SUBJECT: QUAKER VIEW (DSP # 2002-0032) (REZ # 2002-0004)
APPEAL OF A SITE PLAN DENIAL BY THE PLANNING COMMISSION
AND CONSIDERATION OF A REZONING

Docket Item #11 and 12
REZONING #2002-0004(11)
DEVELOPMENT SITE PLAN #2002-0032 (12)
11-21 NORTH QUAKER LANE (QUAKER
VIEW)

Planning Commission Meeting
January 6, 2003

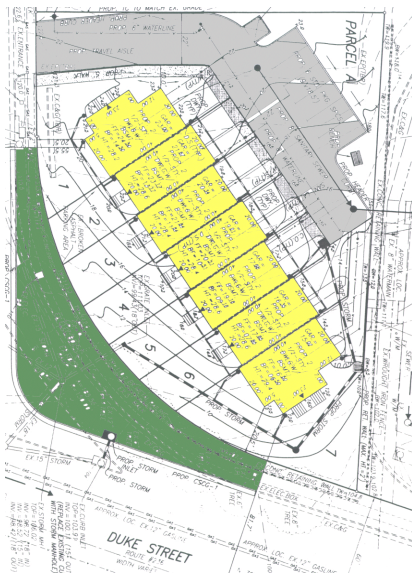
The original plan for this site proposed the removal of the existing free-flow or “hot -right” turning movement lane from westbound Duke Street to northbound North Quaker Lane. A dedicated right turn lane would have remained on Duke Street for the northbound turning movement. This proposal would have enabled additional open space, improved the pedestrian crossing while still providing a dedicated turn lane on North Slaters Lane, with a more traditional “T” intersection.

Input from the community and the nearby fire station on Duke Street (Station #207) indicated a desire to retain the existing “hot right” turning movement. From the Fire Department perspective, it was determined that the removal of the “hot right” turning movement could delay response time from the station to areas north of Duke Street and that a new 90-degree turning configuration could cause problems for the heavy fire apparatus in climbing the grade that exists on North Quaker Lane. The community raised the concern that the elimination of the “hot right” turn would cause delays for turning movements from Duke Street onto Quaker Lane.

In order to address these areas of concern, the applicant revised the site plan to reflect the current retention of the free right. To address concerns regarding access to the site, T&ES staff has

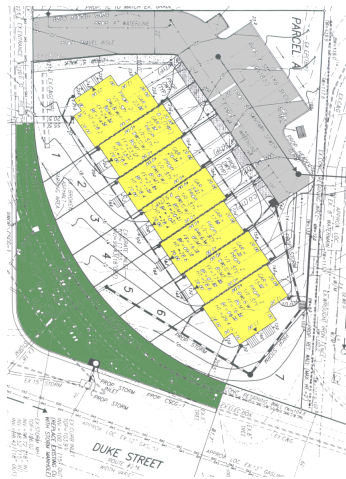
Many of the adjoining residents have raised concerns regarding the safety of the proposed ingress/egress for the site. Initially the applicant proposed elimination of the “free-right” hand turn lane from Duke Street onto North Quaker Lane. The original plan for this site proposed the removal of the existing free-flow or “hot right” turning movement lane from westbound Duke Street to

northbound North Quaker Lane. A dedicated right turn lane would have remained on Duke Street for the northbound turning movement. This proposal would have enabled additional open space, provided a pedestrian crossing while still providing a dedicated turn lane on North Slaters Lane, while providing a more traditional “T” intersection.

Many of the adjoining residents have voiced the concern that elimination of the “free-right” turn would negatively impact this intersection during peak hours. Community opposition and concern from the adjacent Fire Station #207 about the impact to response times and abilities for emergency vehicles to climb the grade of North Quaker Lane from a 90-degree turn have caused the applicant to modify its original plans and retain the existing traffic condition.

In order to address these areas of concern, the applicant revised the site plan to reflect the current retention of the “free right” turn. In addition, to address concerns regarding access to the site, T&ES staff have recommended the extension of the existing Quaker Lane median to the north, to prevent left hand turns from southbound Quaker Lane into the site. Staff is also recommending improvements to signage and crosswalks in the immediate area to improve pedestrian and vehicle movement surrounding the site.
